STATE OF NORTH CAROLINA
DEPARTMENT OF TRANSPORTATION

April 12, 2013

Subject: **Additional Information in Response to the N.C. Division of Water Quality's On Hold Letter for the Modification Request of the Individual Section 404 and Section 401 Water Quality Certification** for the proposed improvements to NC 24 from SR 1853 (John Nunnery Rd.) in Cumberland to US 421-701/SR 1296 (Sunset Avenue) in Sampson County. Federal Aid Project No. STPNHF-F-8-2(17), TIP No. R-2303B, C, and D.

R-2303C Application Comments

Permit Drawing Sheet 35 of 80

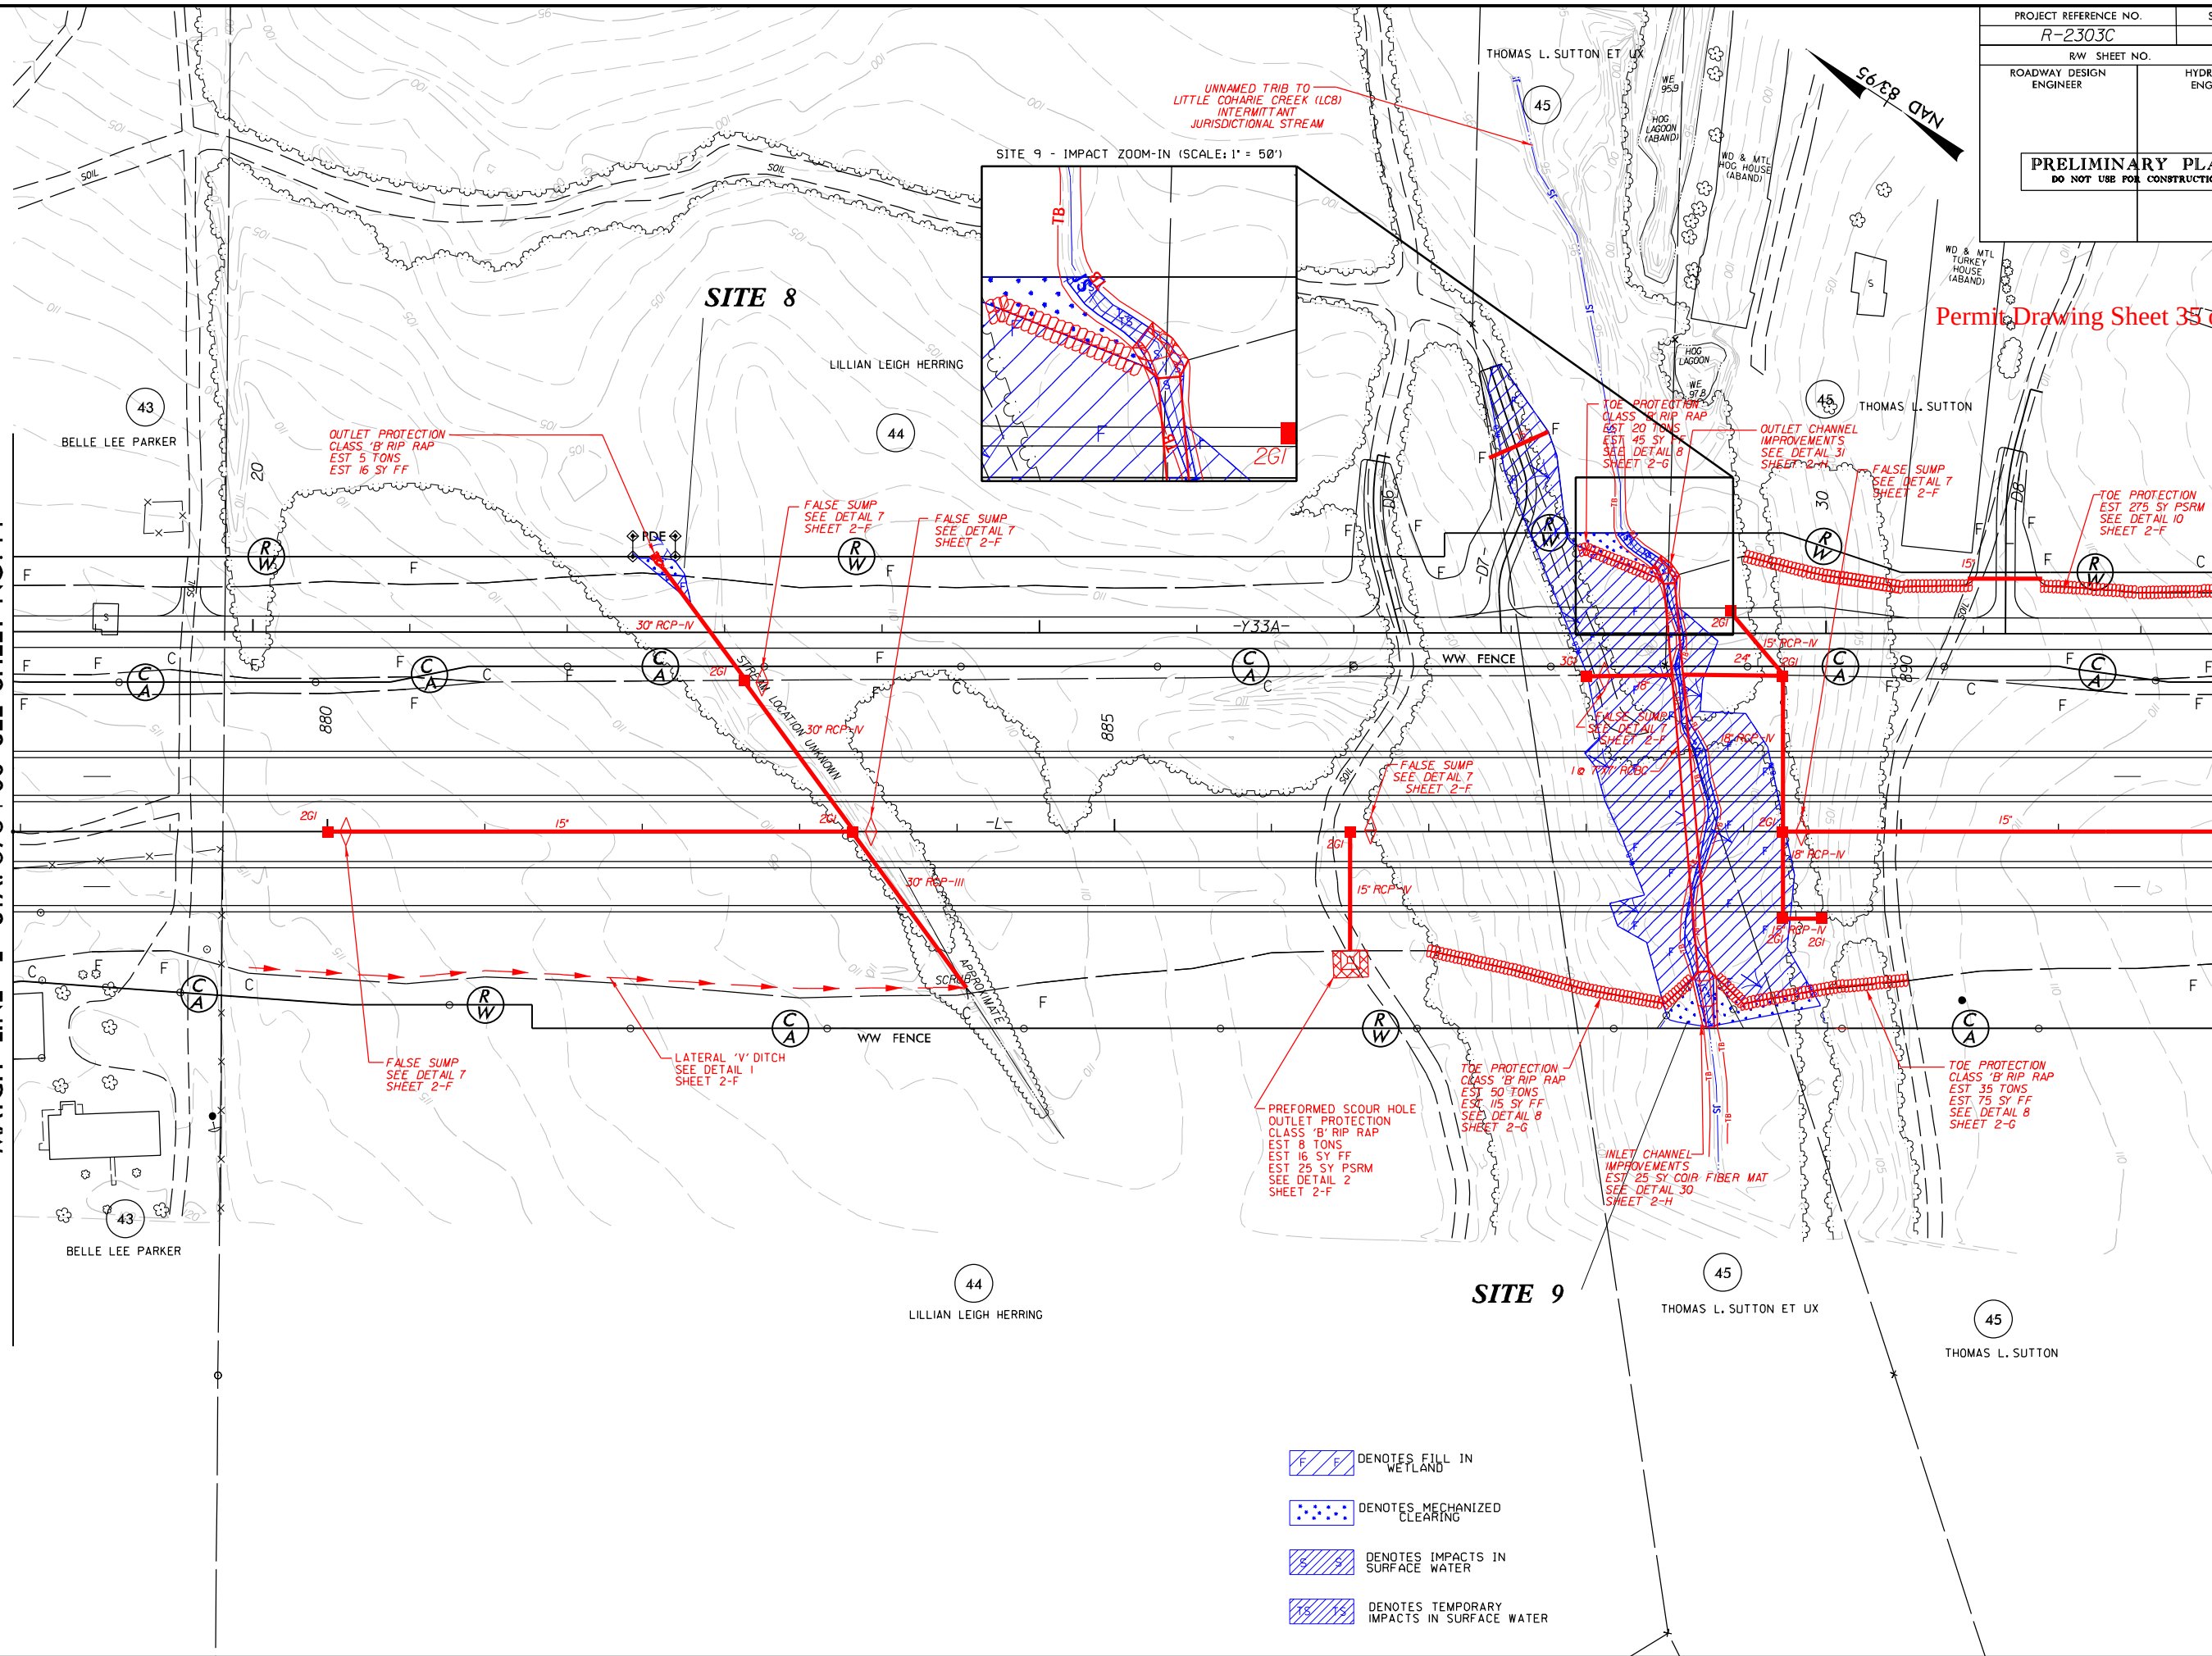
7. Permit drawing 34-35 of 75. Impact summary sheet list 315 lf of stream impacts at Site 11, however the permit drawing scale indicates approximately 190 lf of stream impact. Please clarify.
The length of the “impacts in surface water (pond)” were included in the length.

Permit Drawing Sheet 70 of 80

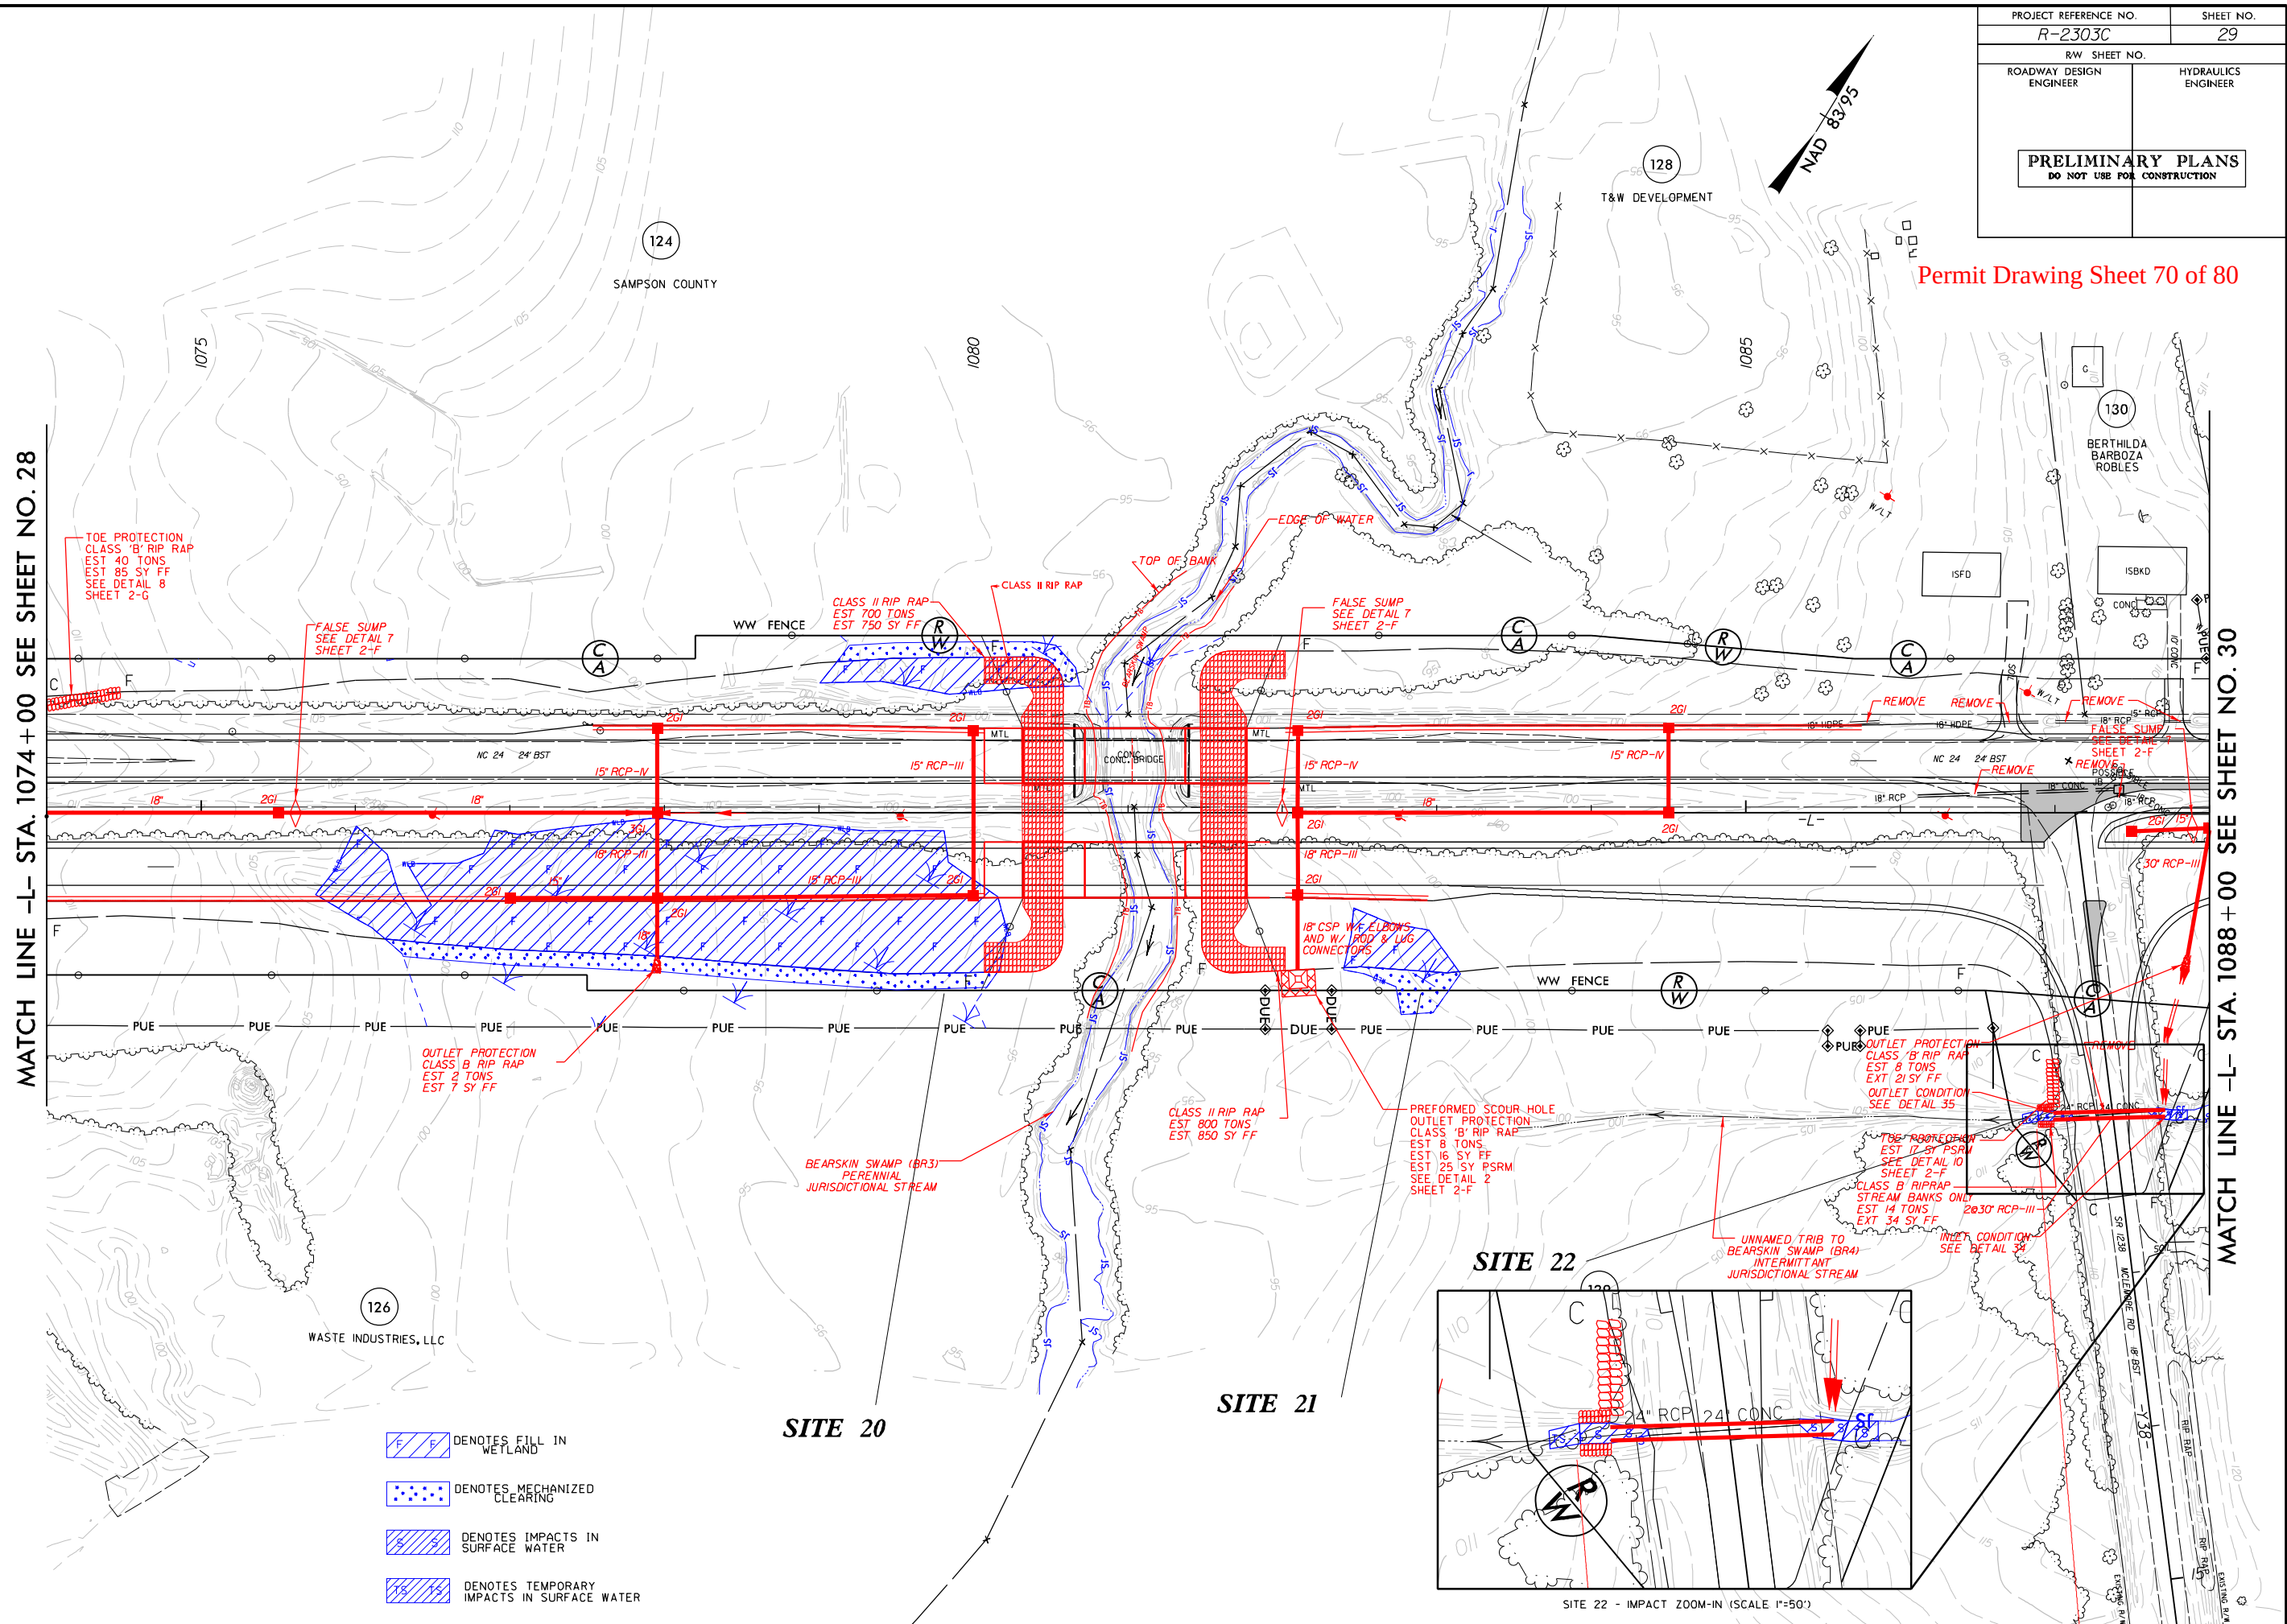
13. Permit drawing 70 of 75, shows 5:1 slopes extending out into jurisdictional resources at Sta. 1092+00. Your application states in the “Minimization and Avoidance” section states that 3:1 slopes will be used in jurisdictional areas. Please correct.

Slopes have been revised to 3:1.

PERMIT DRAWING
SHEET 40 OF 75

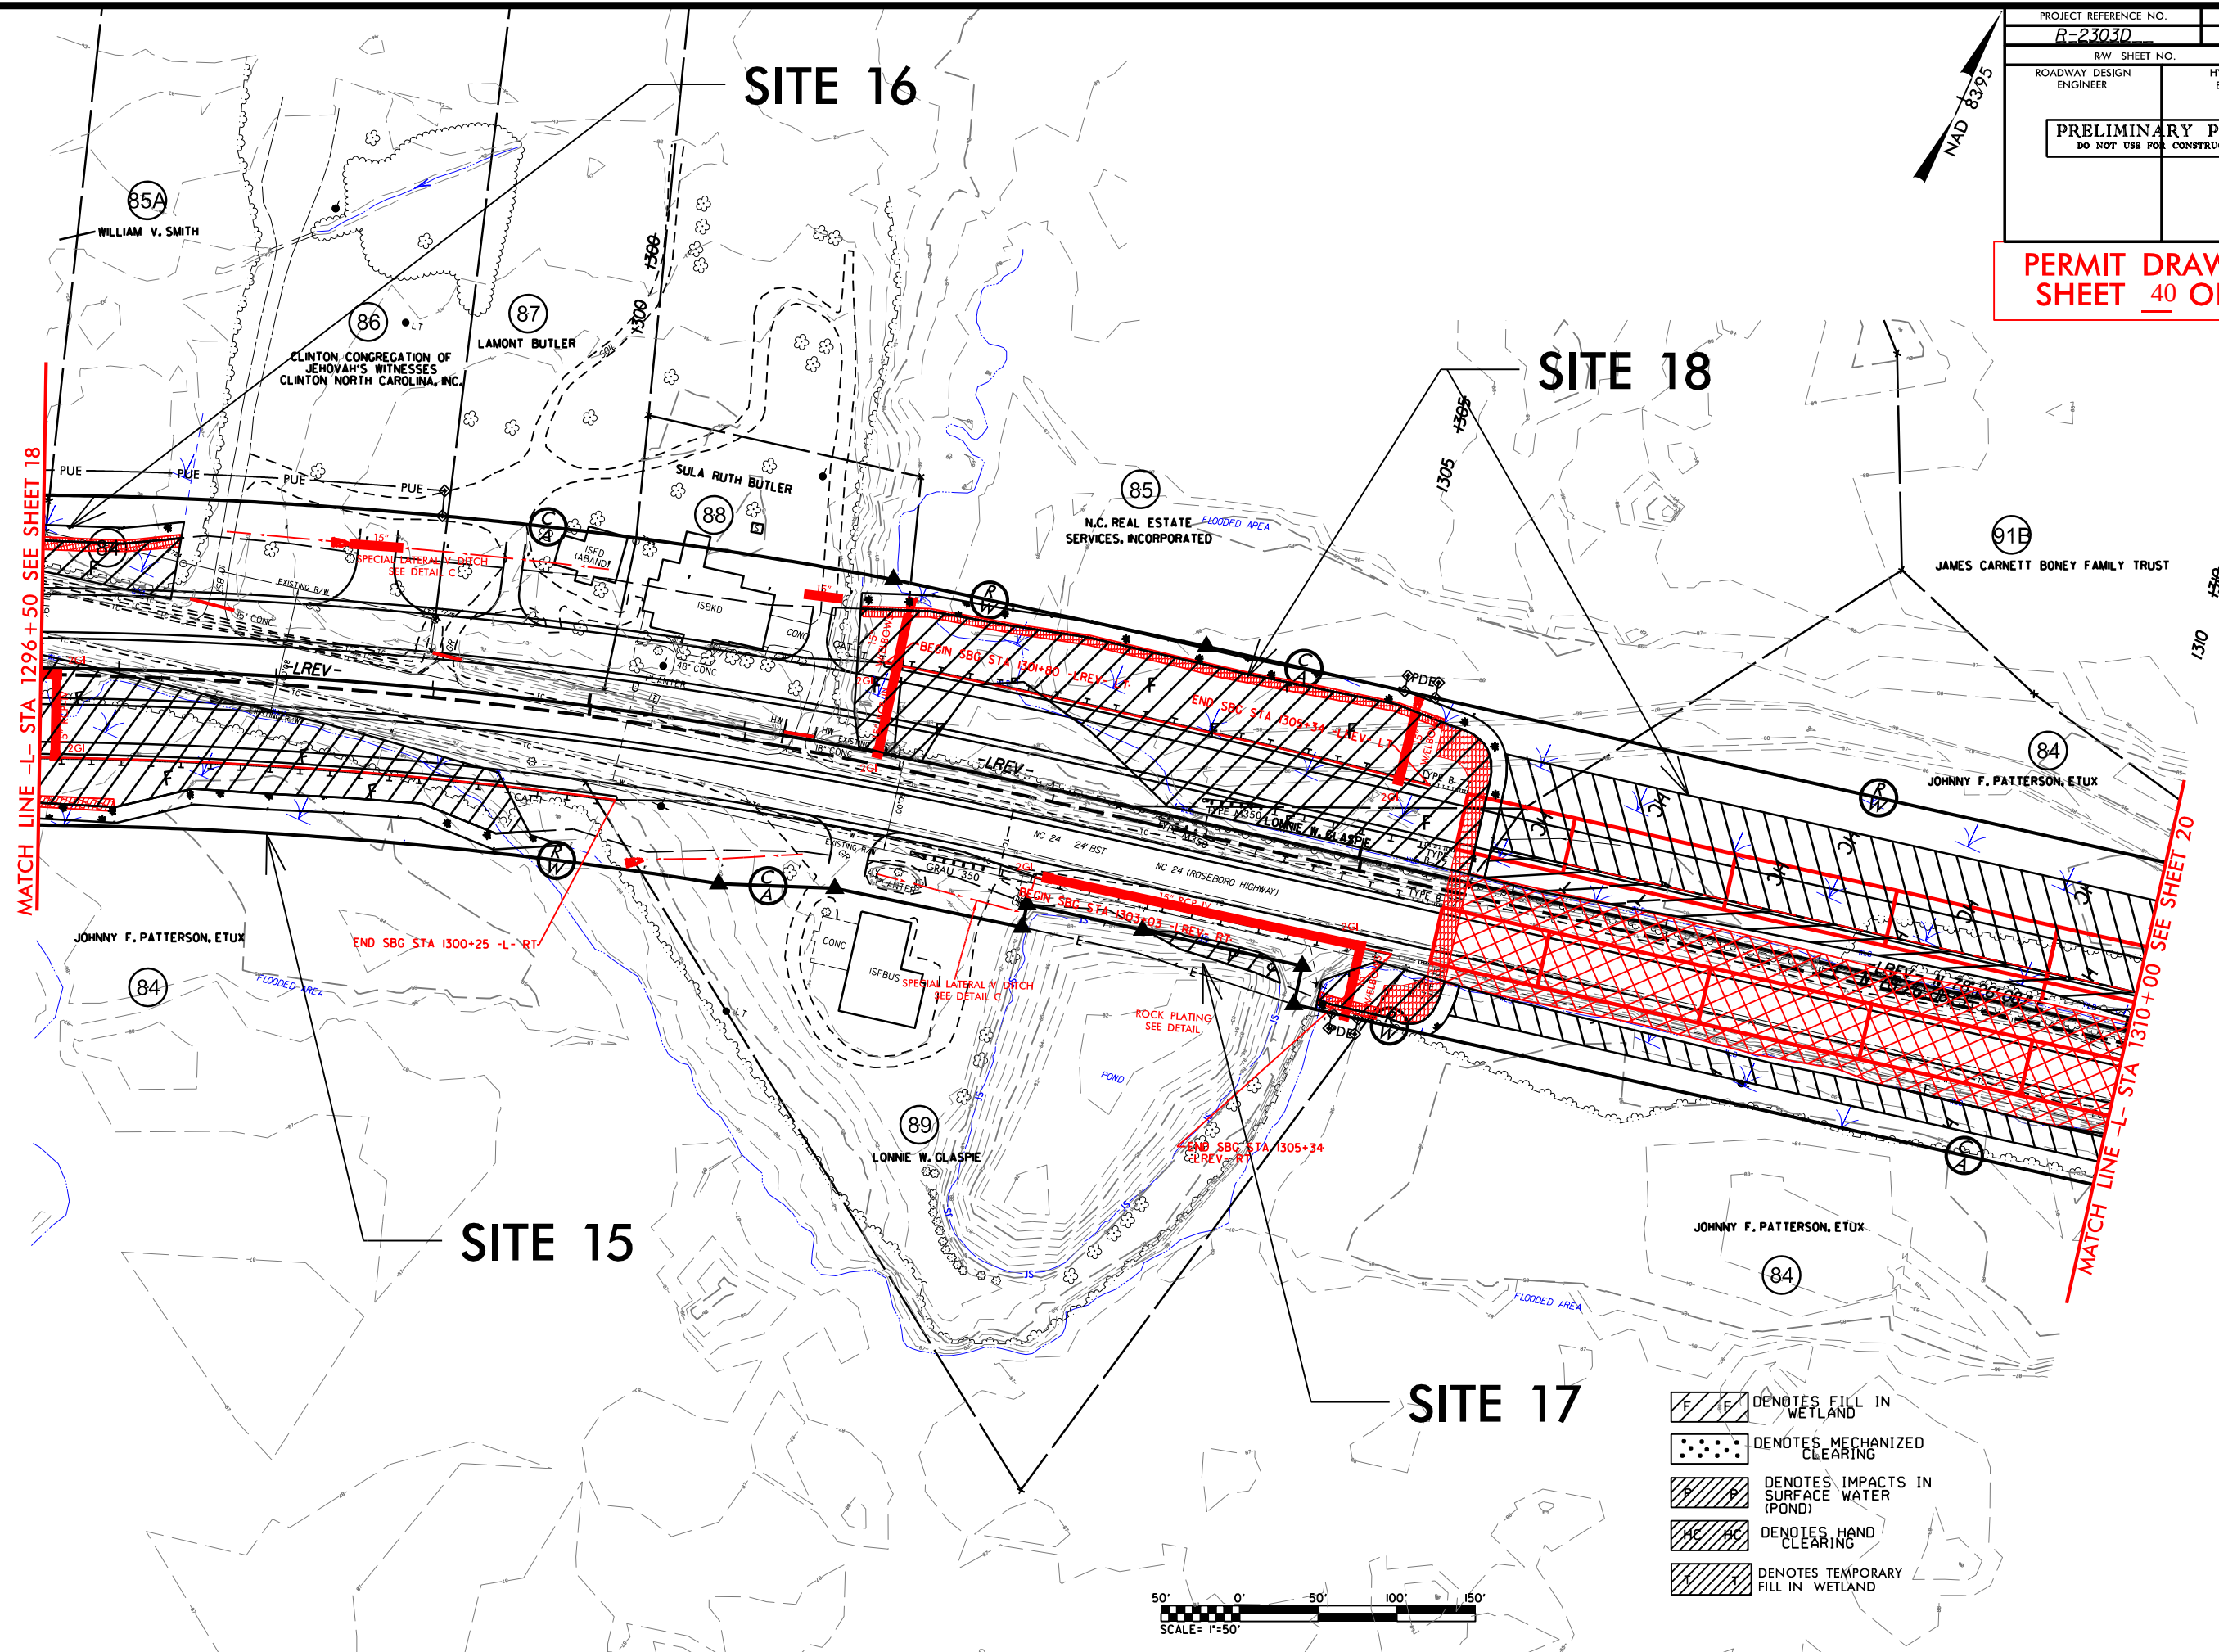
9. Sites 14/15, Permit drawing 40 of 79. Shows >3:1 slopes extending out into jurisdictional resources. Your application states in the “Minimization and Avoidance” section states that 3:1 slopes will be used in jurisdictional areas. Please correct.

Side slopes revised to 3:1 in jurisdictional areas. Impacts updated.
